STAFF REPORT: JUNE 8, 2022 MEETING

APPLICATION NUMBER: 22-7850 VIOLATION NUMBER: 22-592

ADDRESS: 1814 – 1820 CHURCH

SCOPE: REPLACE WINDOWS (WORK COMPLETED WITHOUT APPROVAL)

1814-1820 Church Original Dimensions

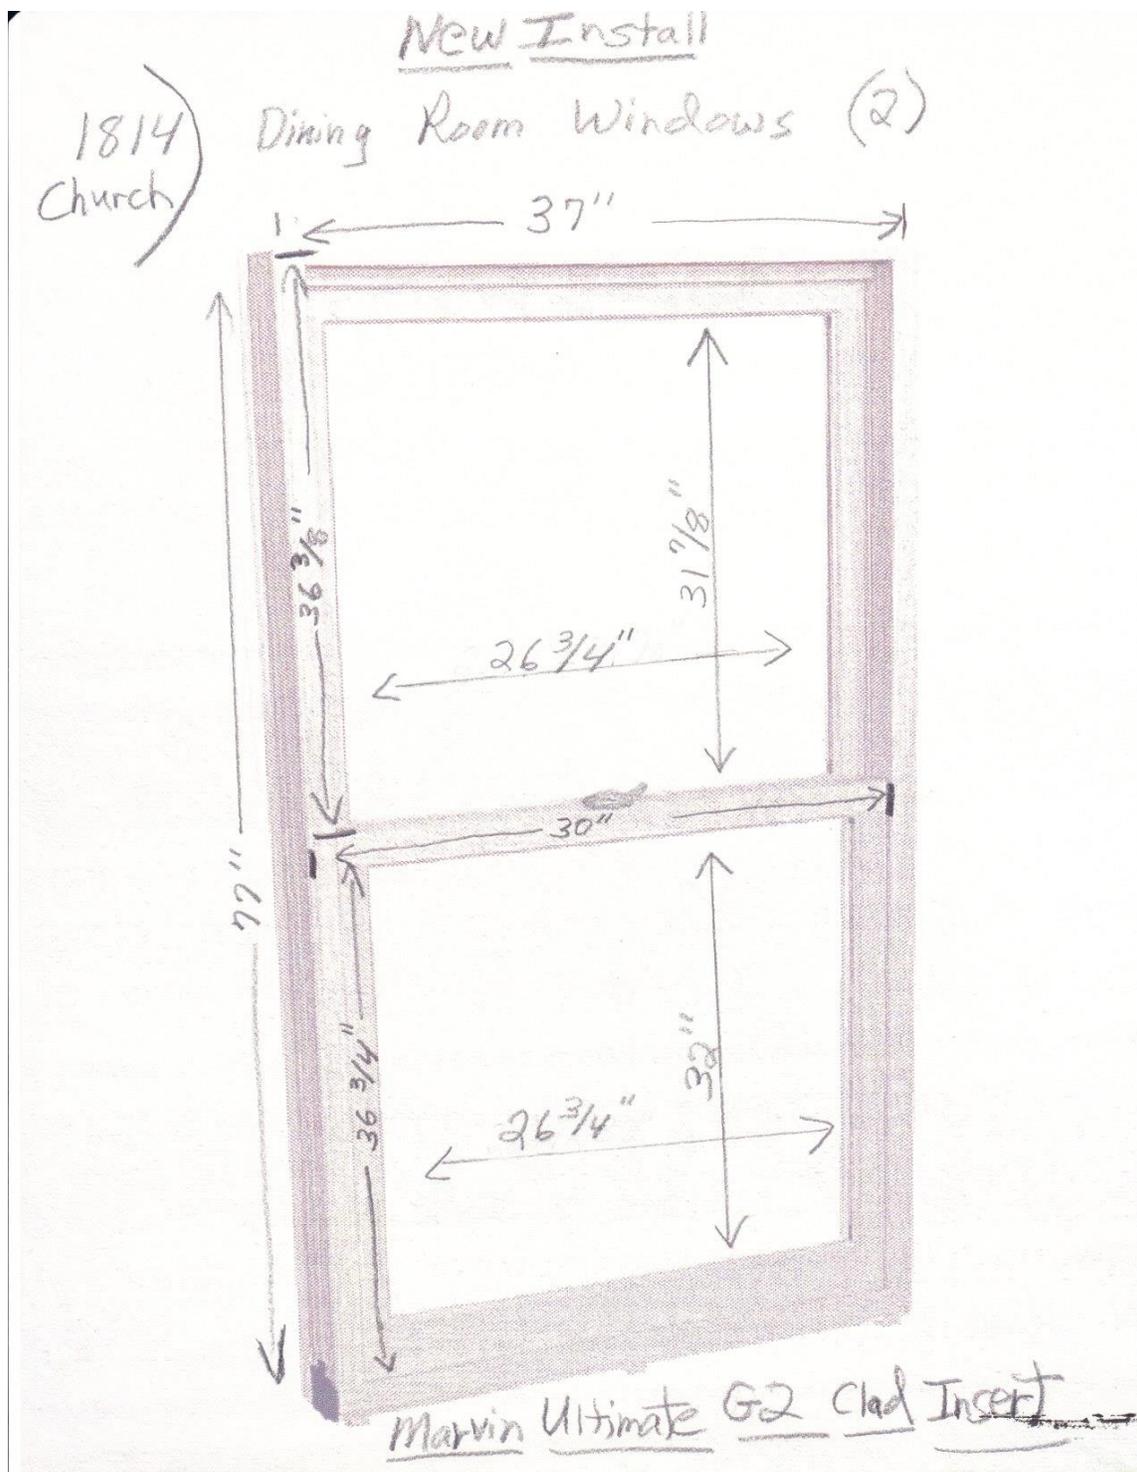
- The applicant states the deteriorated condition of the historic wood sash was significant, in addition to non-functioning weight systems, layers of lead-based paint and cloudy single-pane windows. Based on the provided photos, the wood frames appeared to be intact and not beyond repair, the operating chords and weights could have been replaced, the lead paint mitigated, and the cloudy glass replaced.
- The supplied dimensions of the existing and replacement window units offer the following analysis for the reduction in glass area, as these were the provided dimensions that are most easily compared:

<u>Existing Glass Area</u>	<u>Replacement Glass Area</u>	<u>Dimensional and % Change</u>
33-3/4" high	31-7/8" high	1-3/4" shorter – 6% reduction in height
29-7/8" wide	26-3/4" wide	3-1/8" narrower – 10% reduction in width

1814 Church, East Wall Replacement
Dimensions

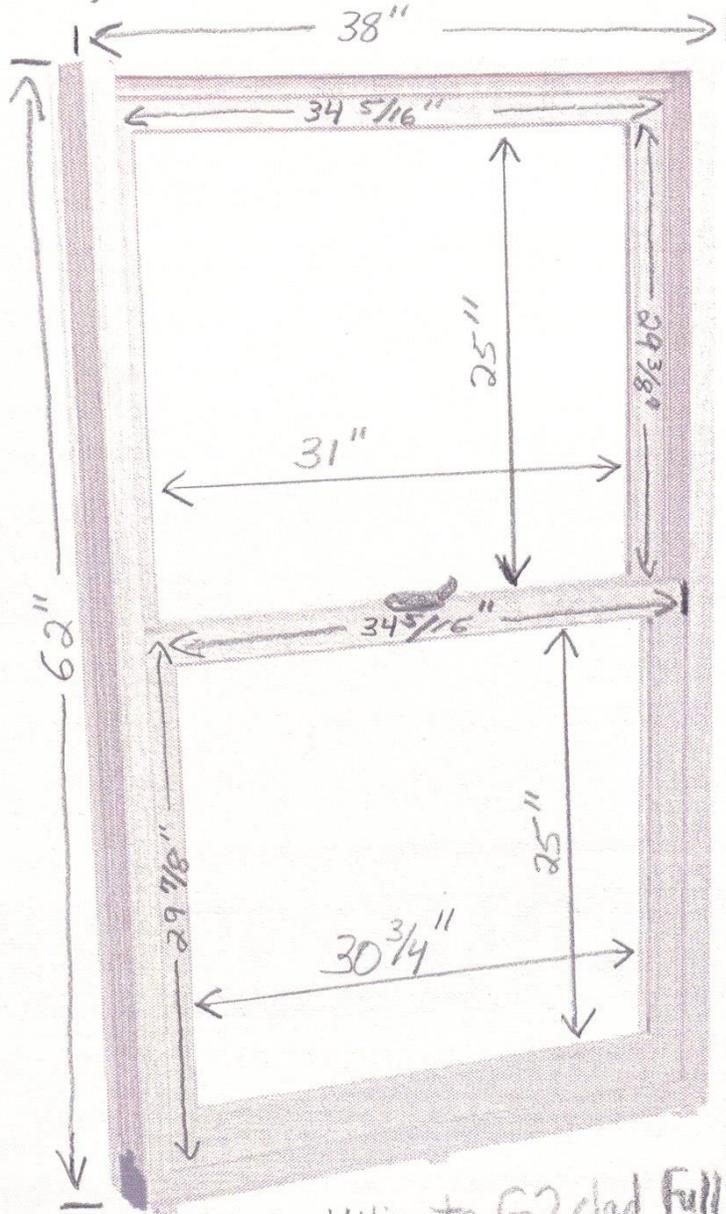
- The applicant provided a photograph of an existing wood window with an aluminum storm frame (below left), as well as a photograph of one of the recently replaced window units (center). The original opening retains the wood brickmold (wood framing) around the window sash. Brickmold fills some of the depth between the outer masonry wall and window unit while adding additional detail to the opening. The recently installed window does not have brickmold in place, so the window appears to sit very far back within the masonry opening and the dimensional framing of the sash has been lost. The double-hung with divided light upper sash (below right), taken by staff, shows a previously replaced unit with a narrow brickmold applied to the sides and top of the sash. While offering some detail, the narrow brickmold is only noticeable due to the contrasting paint color and does not match the dimensions and visual balance (within the full opening) of the original brickmold.
